TRC AGENDA

**CITY OF DELAND
THURSDAY SEPTEMBER 21, 2023 AT 1:30 P.M.
CITY OF DELAND TRC MEETING ROOM
DELAND, FLORIDA**

**CITY OF DELAND
TECHNICAL REVIEW COMMITTEE MEETING
MEETING MINUTES
THURSDAY, AUGUST 17, 2023 -1:30 P.M.
CITY HALL**

City of DeLand
SP23-031
425 SOUTH

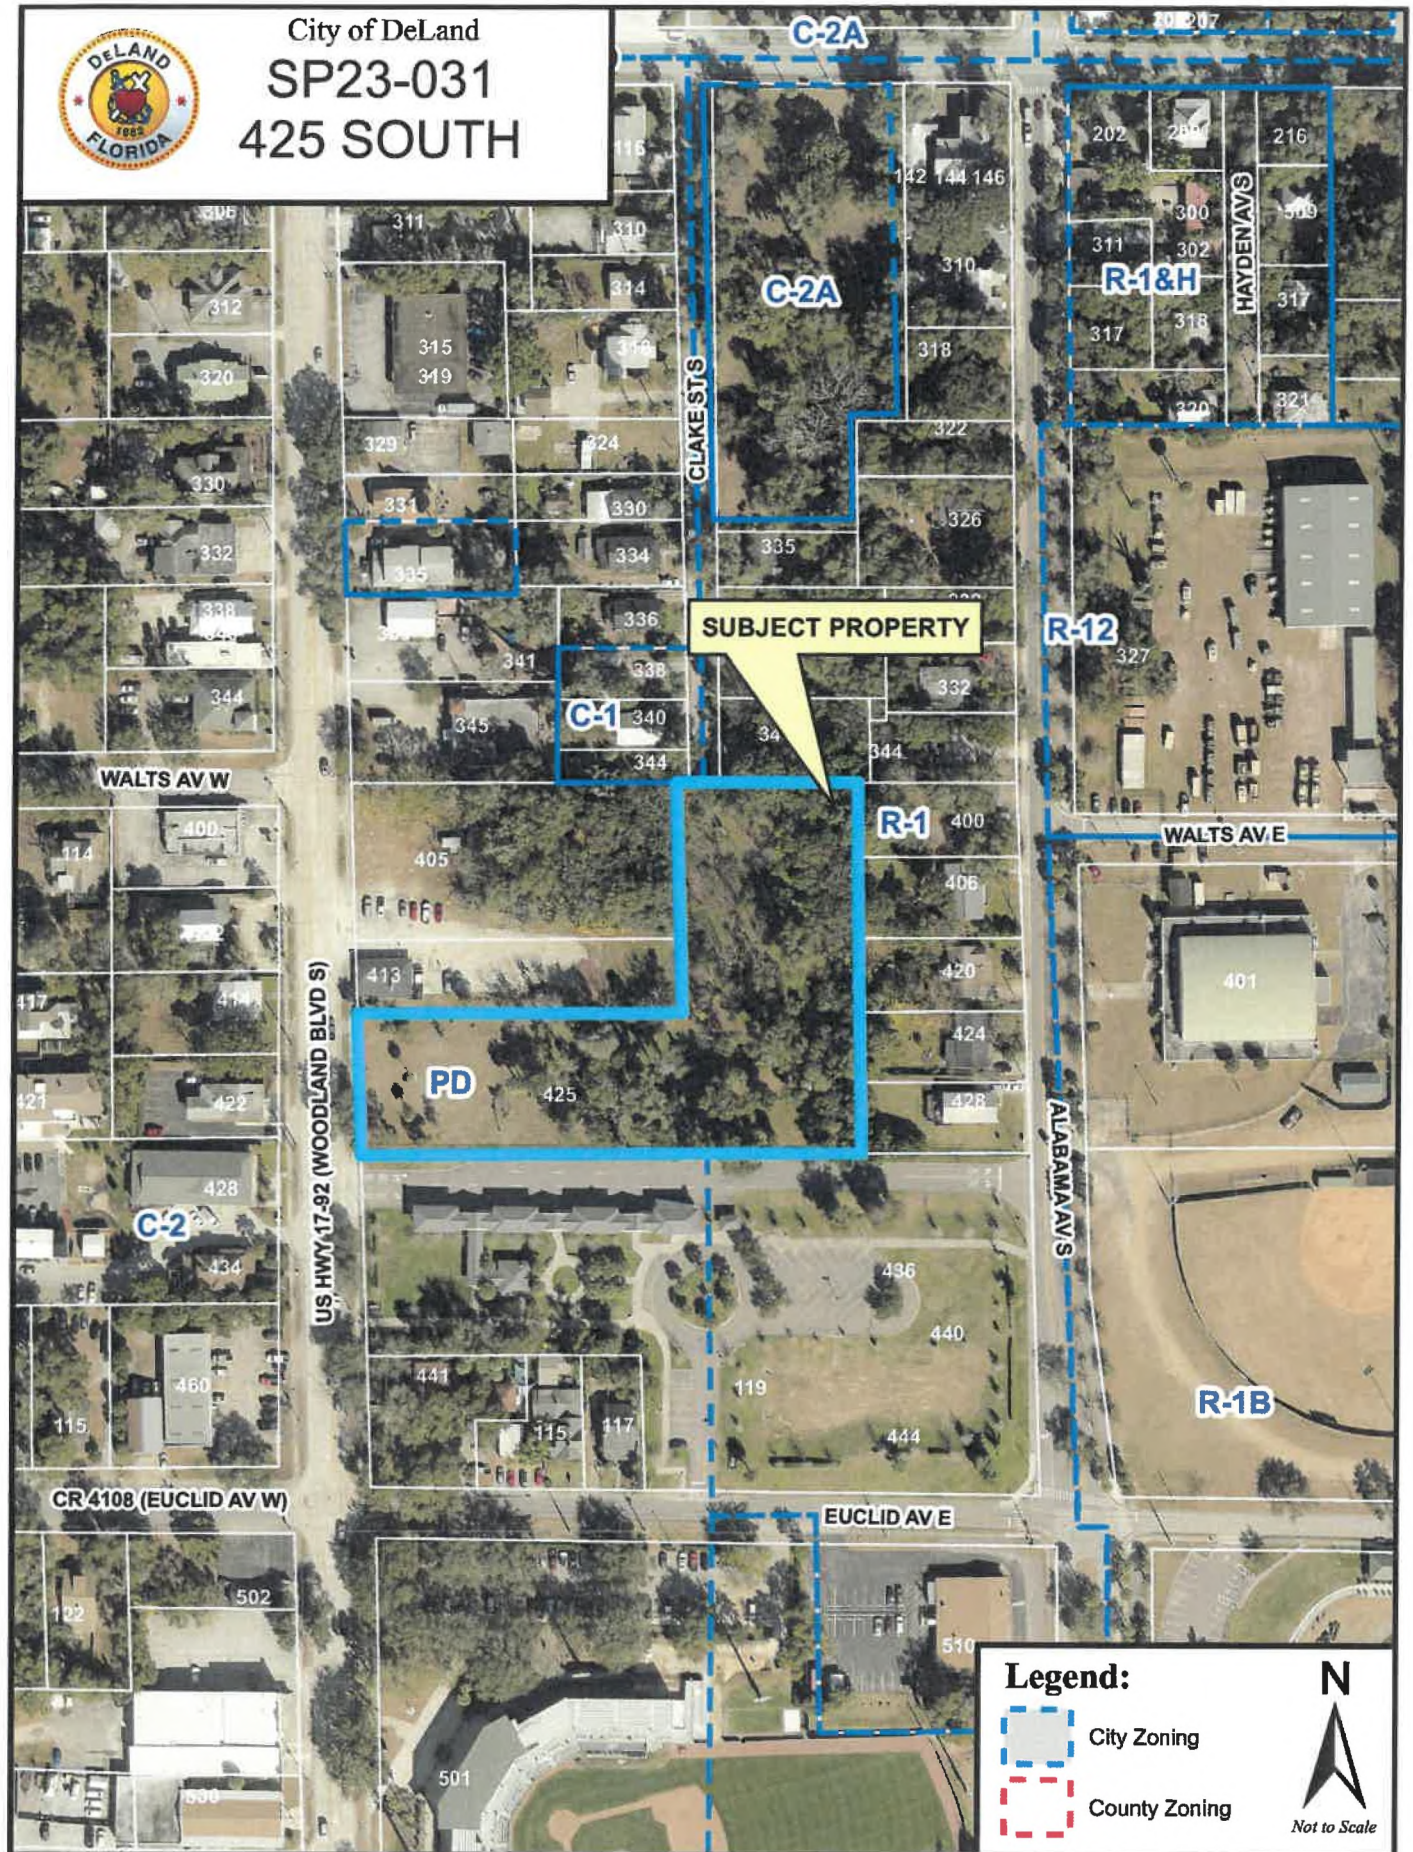
Discipline	Status	Details	Attached To	Created By	Last Updated By	Modifications Required
Engineering	Not Accepted	Grading Plan and Slopes 1. At the handicap space landing area, there is a steep slope change from landing area (EL. 49.97) to adjacent sidewalk grade (EL. 50.92) over a short distance. The slope exceeds ADA max. allowable cross-slope of 2%. Please note that ADA requires cross-slope to be less than 2% and running slope (longitudinal slope) to be less than 5%. 2. Provide a note for the sidewalk adjacent to handicap spaces that the cross-slopes shall not exceed 2%. Show back of sidewalk spot grades to confirm this. 3. On north side of property line just east of the handicap spaces, the back of sidewalk grade drops from EL 49.00 to 46.00. Will the runoff discharge onto the adjacent property? Please note that runoff from this site must be collected and treated on-site and cannot discharge onto adjacent property. 4. Structure S-4, please check require clearance between the 12" storm pipe to top of structure per FDOT Storm Drain Handbook (2014), Table 4-4. There is concerned that the top of pipe (outside diameter) may encroach into the structure top slab. Also, storm pipe must have min. 1-foot of cover. 5. From Structure S-10 to S-11, proposed 8" storm pipe at 0.011% slope produces a velocity of less than 1.0 feet per sec (full-flow). Please adjust pipe invert to meet min. pipe velocity of 2.5 feet per sec to prevent sediment build-up.	05	Tuan Huynh	Ray Bahrami	Yes

Last comment from reviewer: Comment # 3: Runoff from sidewalk area will need to be collected and treated on-site at a minimum. Last response: 1) The slopes over the sidewalk have been updated to meet the 2% cross and 5% running slopes. 2) a note has been added dictating the slopes shall not exceed 2%. 3) The basin adjacent to 425 S. Woodland would make grading to collect 100% of all runoff impossible. 4) Structure S-4 has been designed to meet the 12" min. coverage. 5) Structures S-10 and S11, this is an outflow pipe only to function in the high duration 100 year events and was designed to flow to the lowest elevation on site.				
Fire	Not Accepted	Building Use		Jamie Lunsford	Jamie Lunsford	Yes

Plan Room				
		Provide details on the use of the building. Fire sprinkler system may be required.				
Discipline	Status	Details	Attached To	Created By	Last Updated By	Modifications Required
		Last comment from reviewer: Building will need to be protected with a fire sprinkler system per NFPA101: 36.3.5 Extinguishment Requirements. 36.3.5.1 Mercantile occupancies shall be protected by an approved automatic sprinkler system in accordance with 9.7.1.1(1) in any of the following specified locations: (1) Throughout all mercantile occupancies three or more stories in height (2) Throughout all mercantile occupancies exceeding 12,000 ft2 (1115 m2) in gross area (3) Throughout stories below the level of exit discharge where such stories have an area exceeding 2500 ft2 (232 m2) and are used for the sale, storage, or handling of combustible goods and merchandise (4) Throughout multiple occupancies protected as mixed occupancies in accordance with 6.1.14 where the conditions of 36.3.5.1(1), (2), or (3) apply to the mercantile occupancy Last response: The building use is going to be general commercial / office and has been labeled as such on the cover sheet.

Landscape Buffer/TPA						
Forestry	Draft	You are showing a 10' wide TPA on the north, south, and west sides of the project. Code minimum is 20' width for newly planted TPA's and 30' width for protecting existing trees in a TPA. A variance would need to be asked for and approved in order to count the TPA areas with a 10' width.	09	Kit Dennis	Kit Dennis	Yes
Specimen Tree						
Forestry	Draft	You have indicated that you have one specimen tree on site. Your specimen tree worksheet indicates that 100% of specimen trees are required to be saved. Please indicate why Tree 31 cannot be saved.	09	Mariellen Calabro	Mariellen Calabro	Yes
Tree Removal Index						
Forestry	Draft	Your Tree Removal Index does not match the data in the arborist report. Where is the hickory shown in the arborist report? The number of palms shown on the Tree Removal Index does not match the arborist report, the QL 41 and 45 are not shown, etc. Please update the table with the correct data. Based on what is shown here, your total replacement requirement would be 8" DBH specimen tree replacement and 243" DBH other protected tree replacement for a total of 251" DBH. This will need to be recalculated once the data has been updated to match the arborist report.	09	Mariellen Calabro	Mariellen Calabro	Yes

Crape Myrtle and Holly specifications						
Forestry	Not Accepted	Increase container size to 100 gallon. 45-gallon trees would only receive 2" DBH credit. Last comment from reviewer: You have not changed the 45-gallon to 100-gallon container size on the holly. Last response: The container size has been increased to show 100 gallon and 3" DBH credits.	10	Mariellen Calabro	Mariellen Calabro	Yes

Discipline	Status	Details	Attached To	Created By	Last Updated By	Modifications Required
Forestry	Not Accepted	Magnolia and Live Oak specifications	10	Mariellen Calabro	Mariellen Calabro	Yes
		Increase root ball to 44" and spread to 8'.				
		Last comment from reviewer: Root ball size has not been increased for Live Oak. Last response: The root ball has been increased to 44" and spread to 8'				
Planning	Not Accepted	Wheel stops	17	Belinda Collins	Belinda Collins	Yes
		Add wheel stops to all parking spaces except parallel spaces.				
		Last comment from reviewer: There are 8 spaces south of the maintenance building that do not have wheel stops shown. (This is a simple fix.) Last response: Wheel stops have been added to all, non-parallel parking spaces.

City of DeLand
MS23-061
TAYLOR
MINOR SUBDIVISION

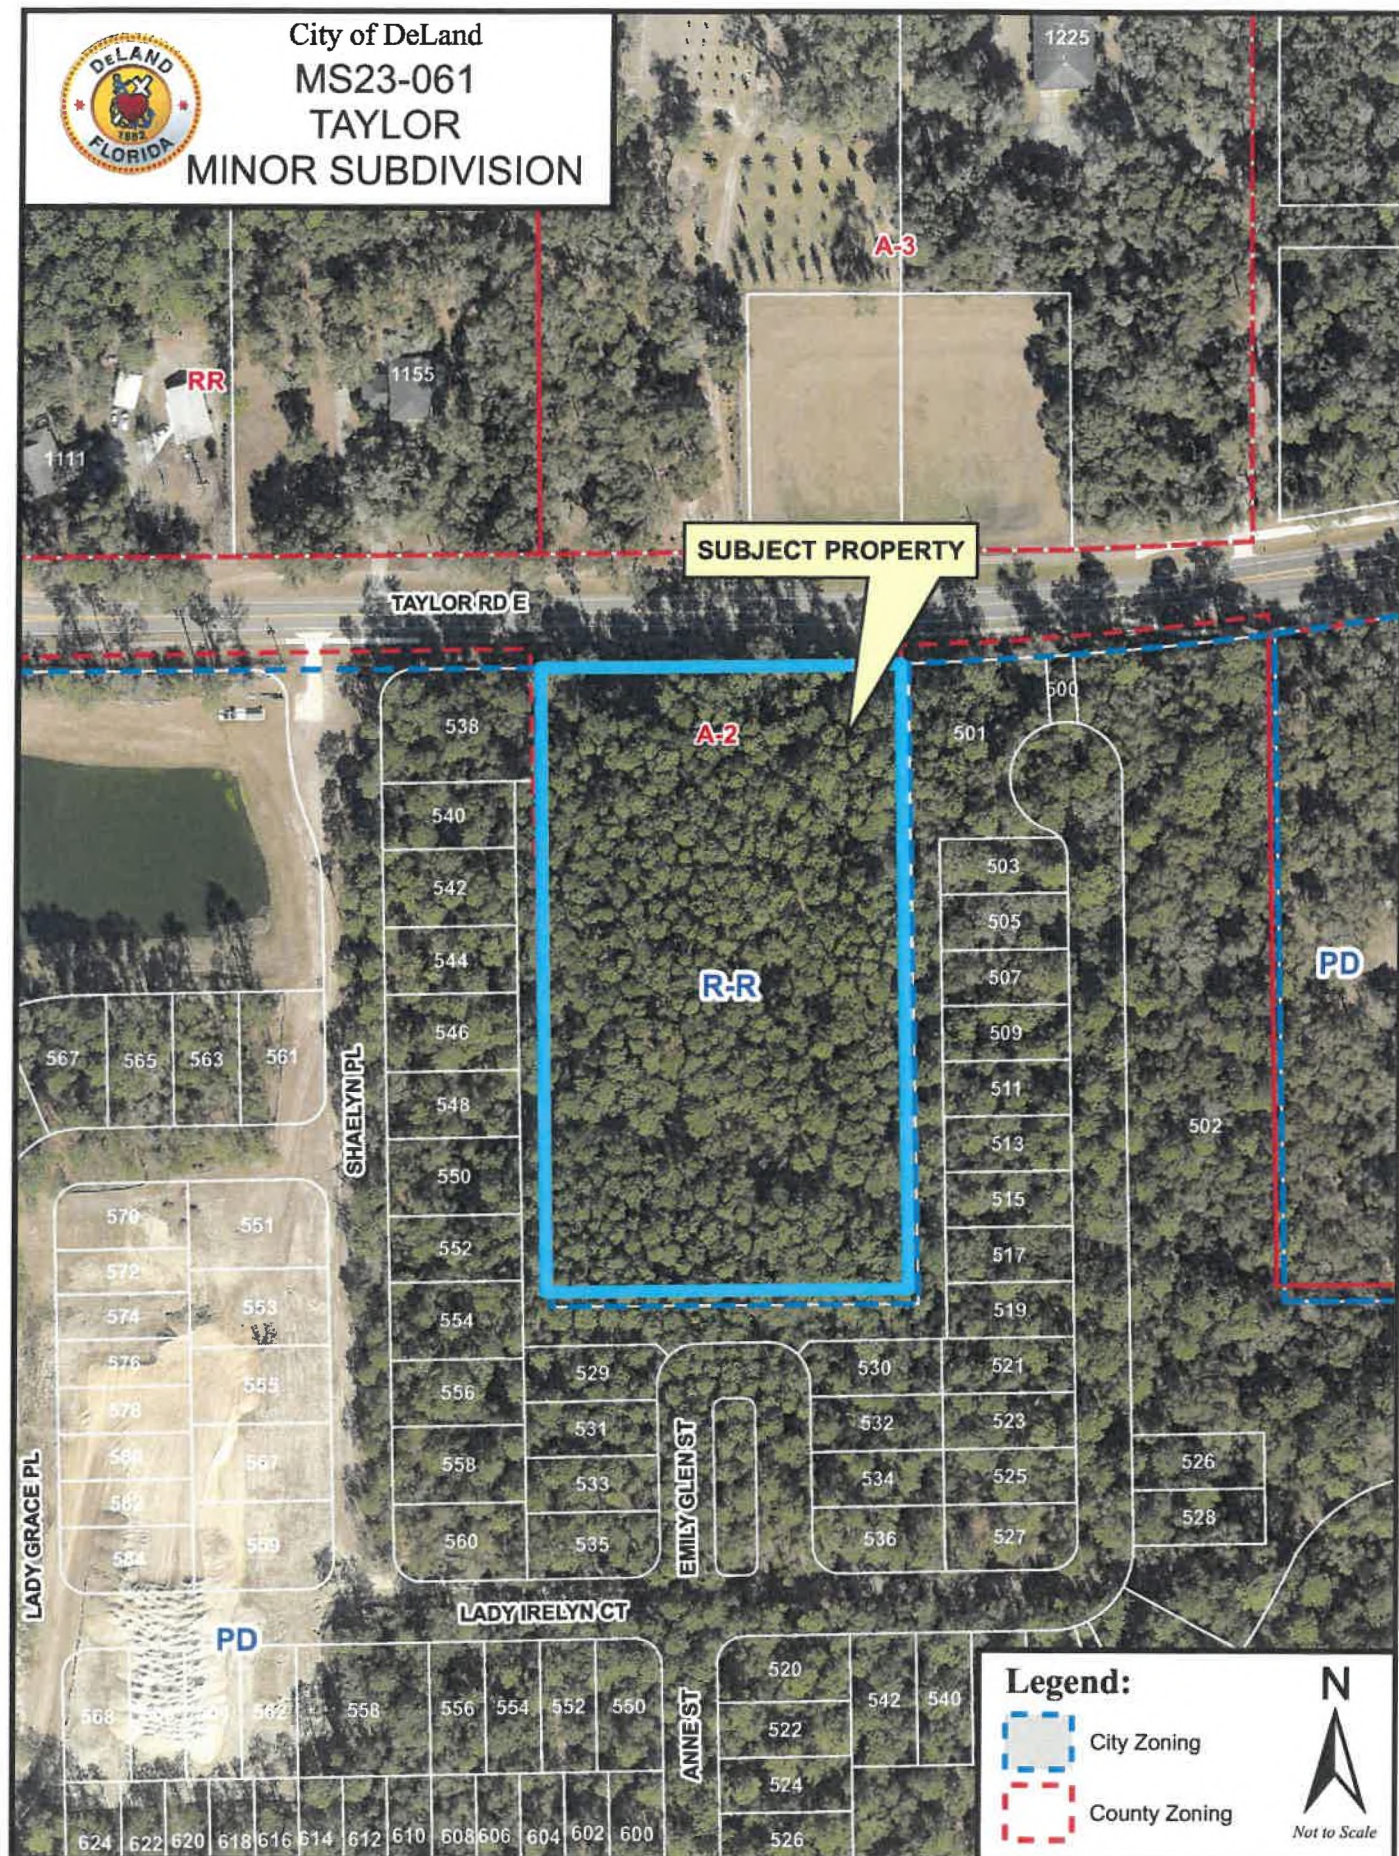
Discipline	Status	Details	Attached To	Created By	Last Updated By	Modifications Required
Dead End Access						
Fire	Not Accepted	A solid compacted area needs to be provide to allow emergency vehicles the ability to turn around. Road exceeds the 150 ft max.	FAX-407.320.8165	Jamie Lunsford	Jamie Lunsford	Yes
Last comment from reviewer: No changes made. Still does not meet the requirements.						
Historic Trees						
Forestry	Draft	No tree information has been provided. Please provide the location of any historic trees on the property.	Taylor Subdivision Redline.pdf	Mariellen Calabro	Mariellen Calabro	Yes
Historic Tree Survey						
Forestry	Not Accepted	A historic tree survey is required.	FAX-407.320.8165	Kit Dennis	Mariellen Calabro	Yes
Cross-Access Easement						
Planning	Not Accepted	Please provide a copy of the recorded cross-access easement between the lots and include the reception number on the Minor Subdivision exhibit.		Samuel Nelson	Samuel Nelson	Yes

Last comment from reviewer: Prior to issuing an approval letter, revised plans and a recorded cross access easement will be required.						
Sewer						
Utilities	Not Accepted	A private lift station would be required for the lot split and force main connection on north side of Taylor Road. If sewer connection is not required, septic tanks must be the advanced OSTs units that comply with the Volusia Blue B-Map since this sight is located in the priority focus area.	FAX-407.320.8165	Jim Ailes	Jim Ailes	Yes
Last comment from reviewer: No response						
Reclaim						
Utilities	Not Accepted	Reclaim is available on north side of Taylor Road	FAX-407.320.8165	Jim Ailes	Jim Ailes	Yes
Last comment from reviewer: No response

Discipline	Status	Details	Attached To	Created By	Last Updated By	Modifications Required
Utilities	Not Accepted	Water Water is available on E. Taylor Road south side. Last comment from reviewer: No response	FAX-407.320.8165	Jim Ailes	Jim Ailes	Yes
